<b>T.I. no.:</b> 2025-12 <b>Updated:</b> -	<b>Topic:</b> Leaky hot water outlet
---	--------------------------------------

## LEAKY HOT WATER OUTLET

Figure 1: hot water outlet external

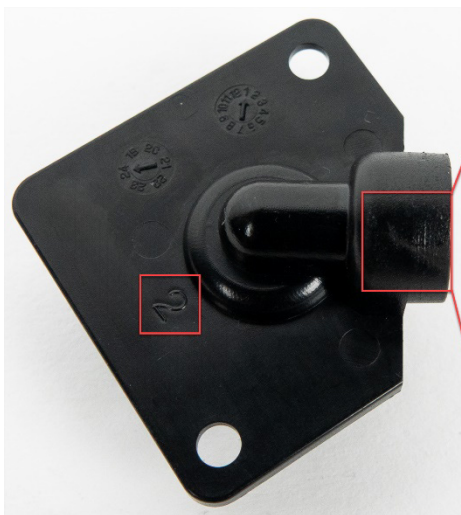
During a quality inspection, it became clear that some hot water outlets have product defects. This is due to a tooling error by the manufacturer, which resulted in the plastic material not being properly fused at one point. The defect only occurs in components marked with a 2. An unclear material fusion point is visible on the outside of the affected area and a crack is visible on the inside. Outlets that are tight during assembly will remain tight. Spare parts for machines with a production date between 2025-01-01 – 2025-03-01 can be ordered under warranty through the official channels.

The 2 mark and the problematic fusion point can be seen on the A crack can be seen on the inside of the hot water outlet.
